# CITY OF CANNON BEACH

## **WATER RESILIENCY PHASE 1 – SEISMIC IMPROVEMENTS**

### **ADDENDUM TO ITB - 2**

DATE: August 22, 2023

SITE & EROSION CONTROL PLAN -  
ISOLATION VALVE 4

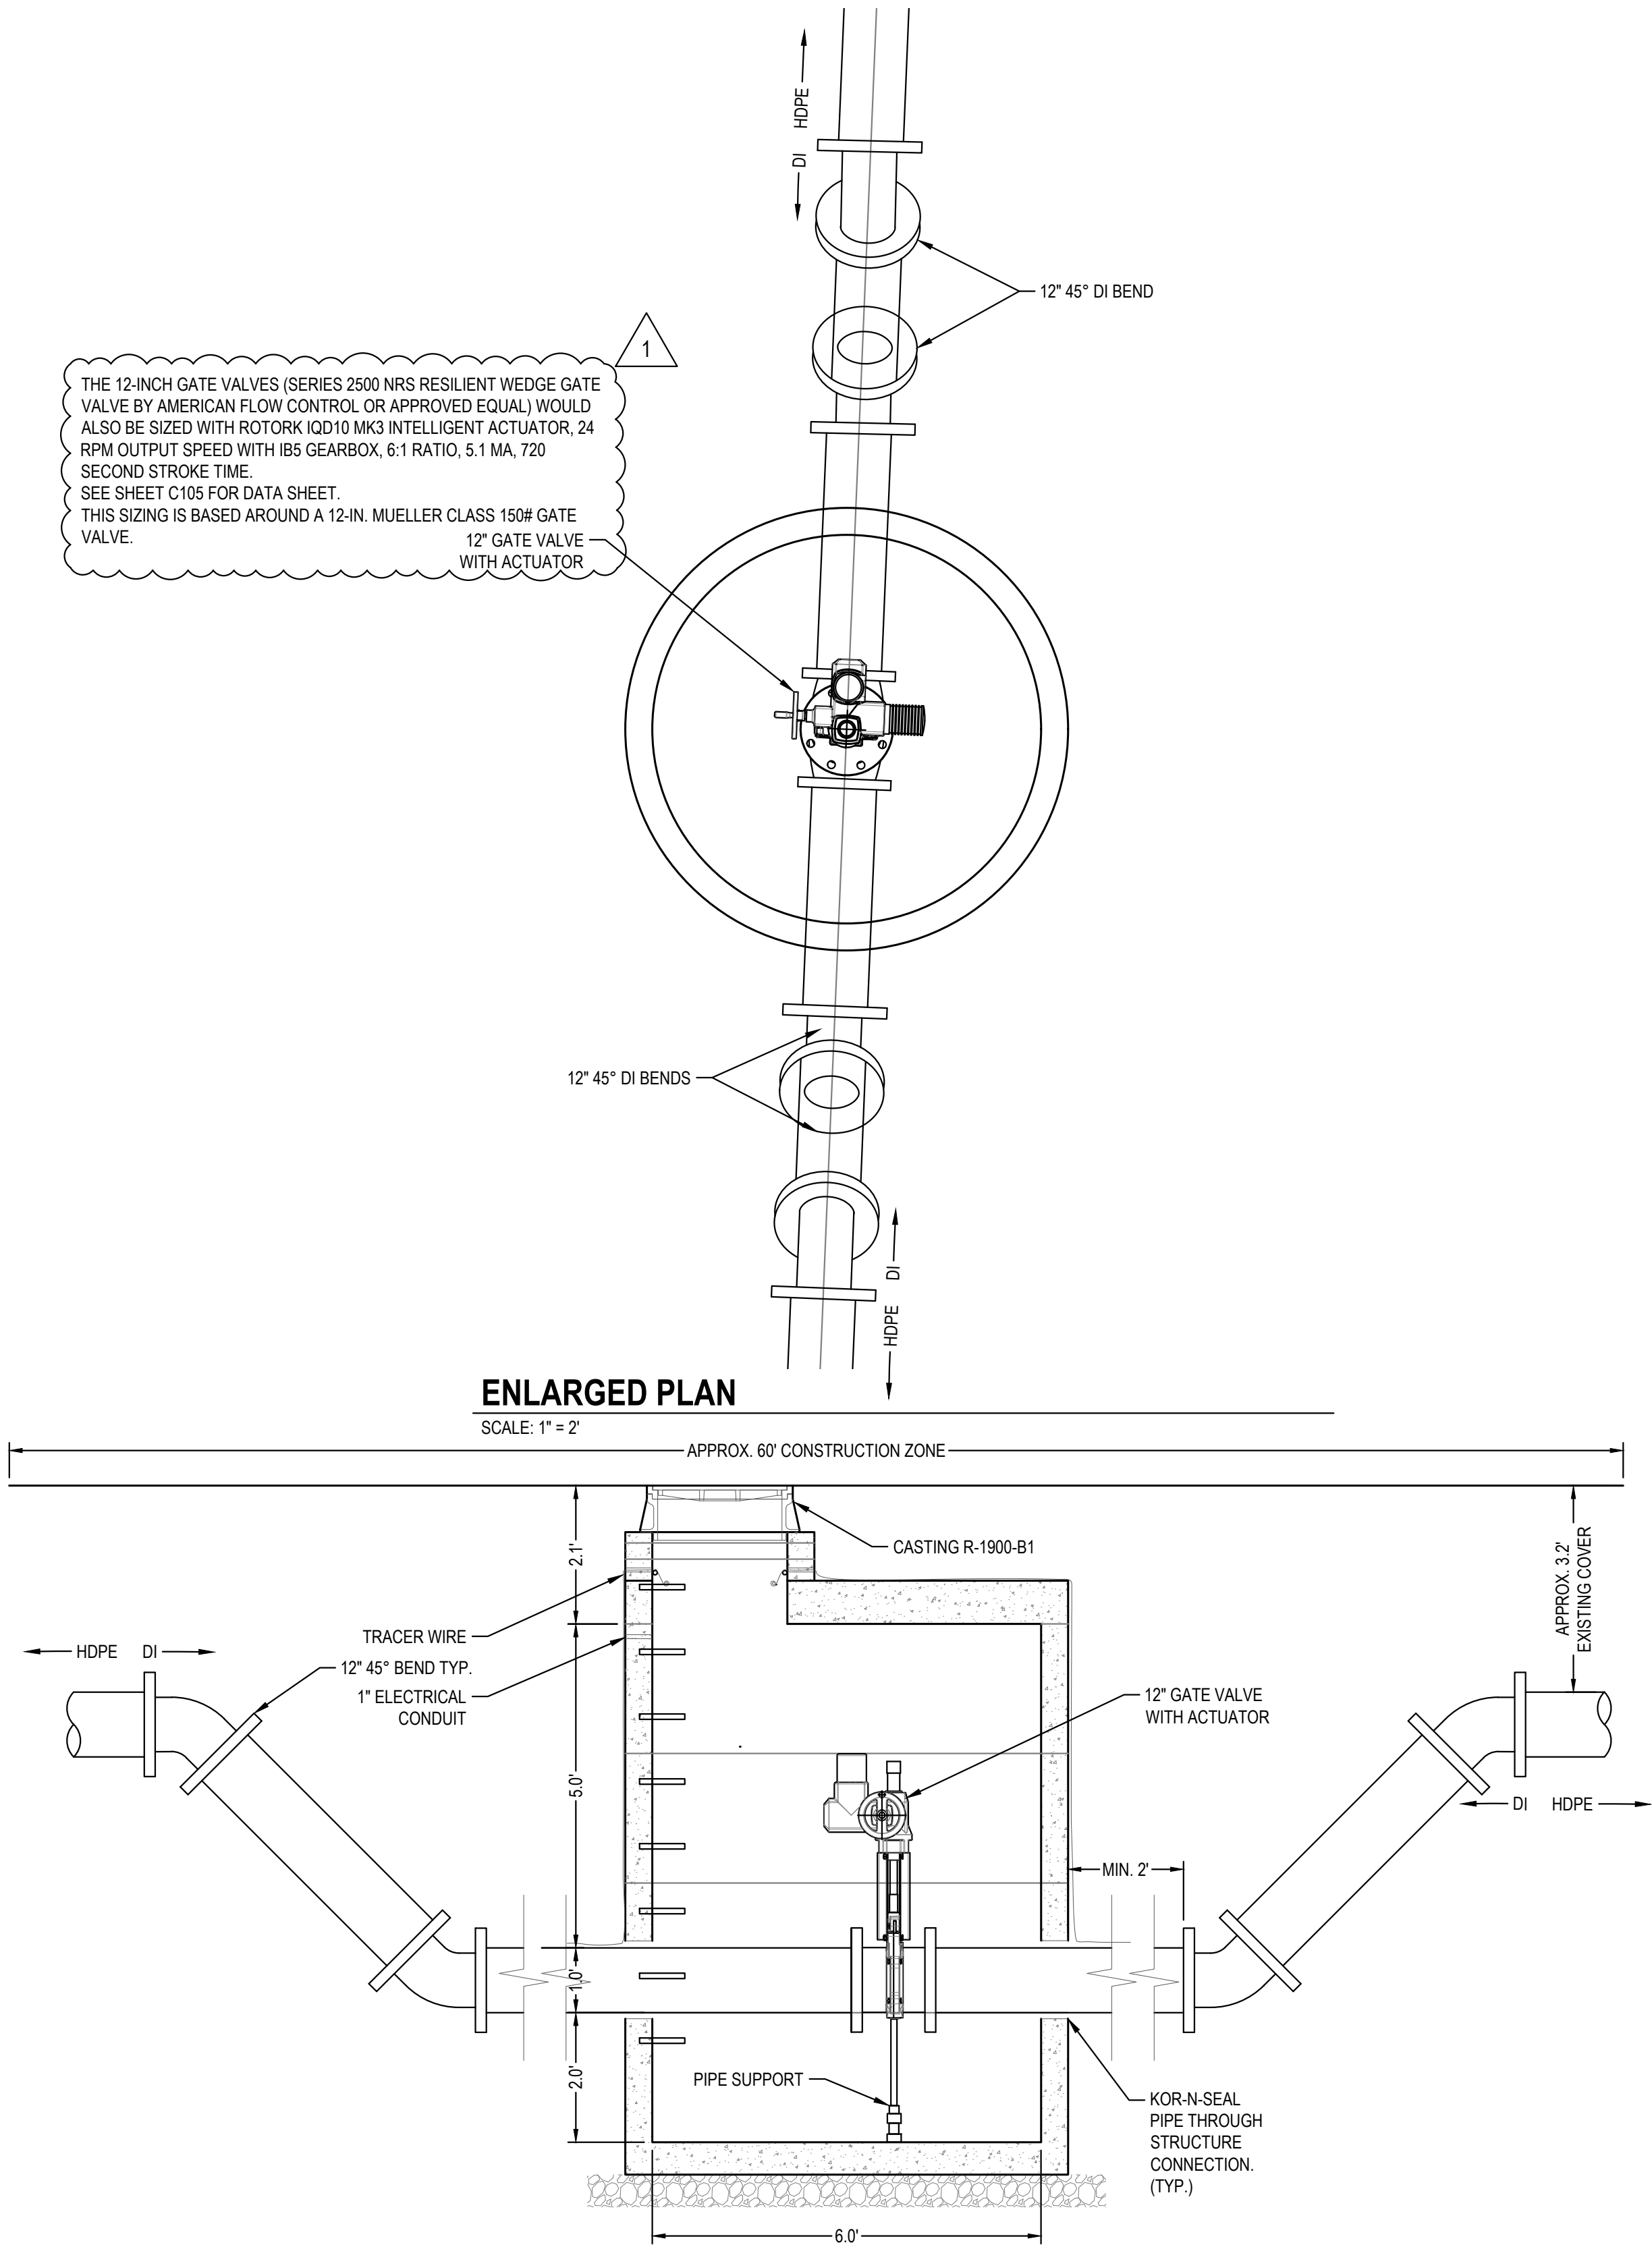
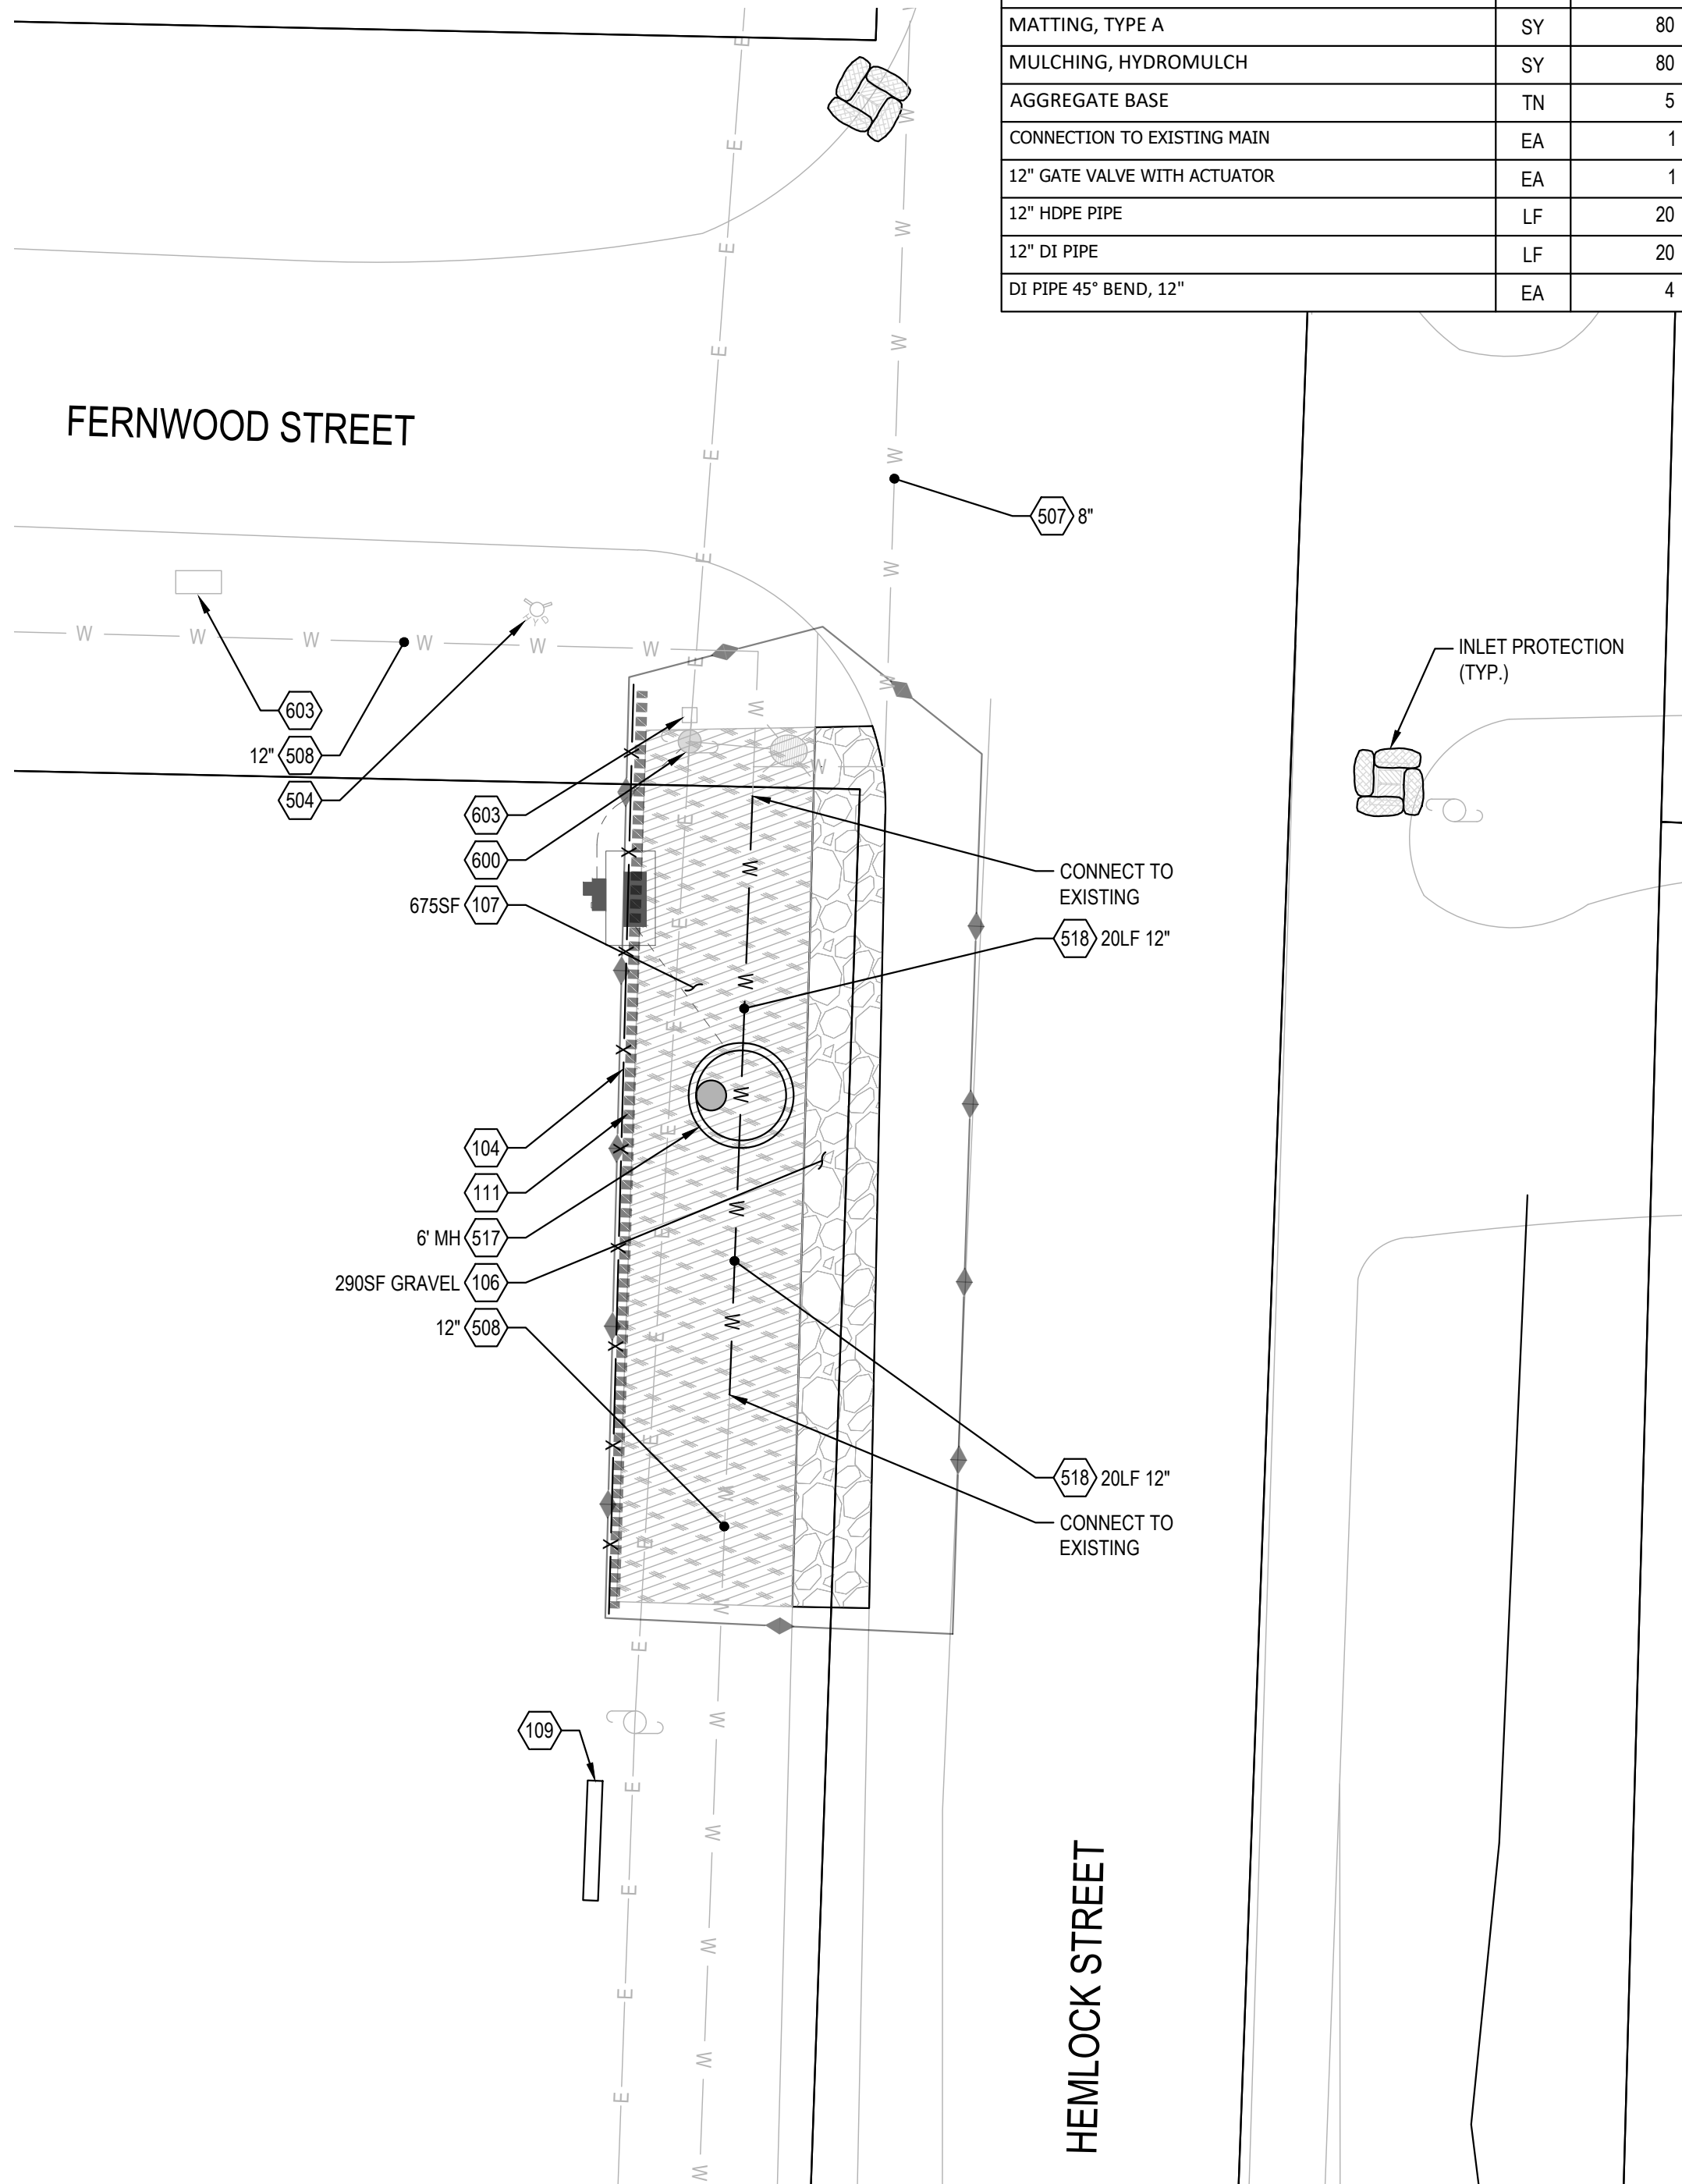
10. Q: Can you specify the approved fittings/adaptors required for connecting the existing Asbestos pipe to the new HDPE pipe on Drawings C100 (Main Reservoir) and C106 (Isolation Valve 4)?

15. Q: On plan sheet C106 there is a 12” Gate Valve which appears to have an electric motor actuator. Is this a standard gate valve or a knife gate?

A: Romac or similar repair clamp stainless steel. Contractor to verify OD and coordinate with supplier.

- A:
1. This is a standard gate valve.
  2. The 8-inch Gate Valves would be sized with **Rotork IQD10 Mk3 Intelligent actuators**, 48 rpm Output Speed with **IB4 gearbox**, 4:1 ratio, 3.4 MA, 160 second stroke time. See attached data sheet. This sizing is based around an 8-in. Mueller Class 150# Gate Valve.
  3. The 12-inch Gate Valves would also be sized with **Rotork IQD10 Mk3 Intelligent actuator**, 24 rpm Output Speed with **IB5 gearbox**, 6:1 ratio, 5:1 MA, 720 second stroke time. See attached data sheet. This sizing is based around a 12-in. Mueller Class 150# Gate Valve.
